DEVELOPMENT REVIEW COMMITTEE (DRC) COMMENT REPORT

PROJECT NAME: Seven Seas II

CASE NUMBER: R18061

REQUEST: Site Plan Level II Review: 6 Multifamily
Residential Units

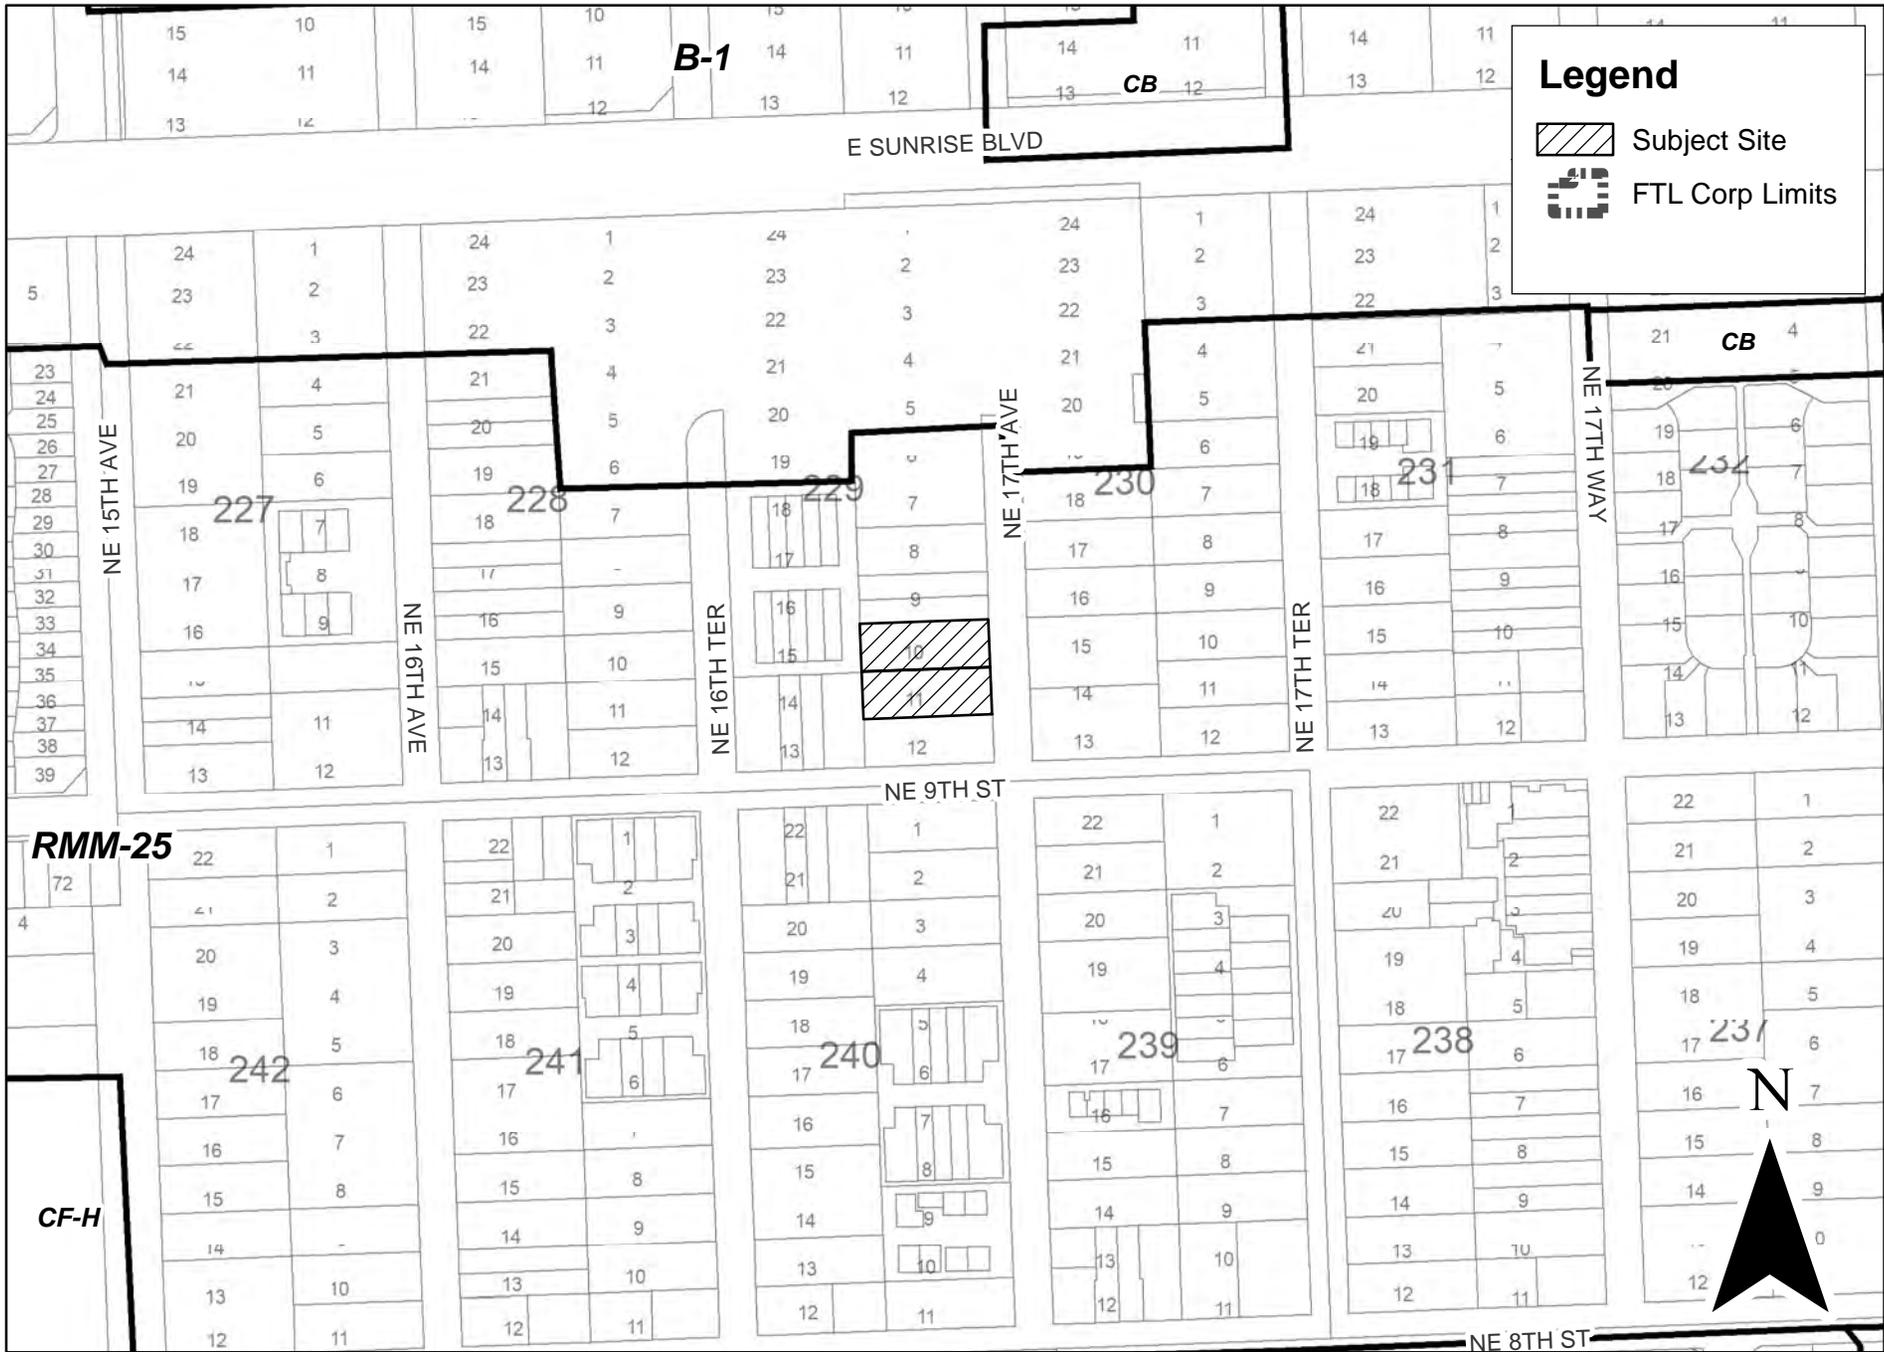
- 1) The applicant is strongly encouraged to contact neighbors adjacent to, as well as condominium and neighborhood associations located within three hundred feet (300') of the development site, to advise of this proposal (a listing of officially-recognized associations is provided on the City's website: www.fortlauderdale.gov/neighbors/civic-associations and a map of neighborhood associations may be found at: <http://gis.fortlauderdale.gov>). Please provide acknowledgement and/or documentation of any public outreach.

- 2) The site is designated Medium-High Residential on the City's Future Land Use Map. The proposed use is permitted in this designation. This is not a determination on consistency with Comprehensive Plan Goals, Objectives and Policies.

- 3) Verify that the copy of plat provided with the application is the most current recorded plat, including notes and amendments, for the proposed site. Provide documentation from the Broward County Planning Council verifying that the site does not require platting or replatting. If replatting or platting is not required, contact the Development Review Services Section of the Planning and Environmental Regulation Division of Broward County at (954) 357-6637 to ensure that proposed project is consistent with the latest recorded plat restriction.

- 5) Provide the following changes on the site plan:
 - a) Per Note B of Section 47-5.36. Table of dimensional requirements for the RMM-25 district, "in no case shall the dimensional requirements be less than an amount equal to one-half (1/2) the height of the building, when this is greater than the above specified yard minimums." The table on Sheet SP-1, Site Plan & Site Data, needs to be updated to reflect the correct required setbacks. Additionally, clearly dimension the setback from the property line to the building envelope on Sheet SP-1 and Sheet SP-2.

- b) Measurements for the north and south side yard setbacks for units 905-2 and 909-5 on Sheet SP-1, Site Plan & Site Data are labeled incorrectly, showing 15'-10", rather than 17'-5".
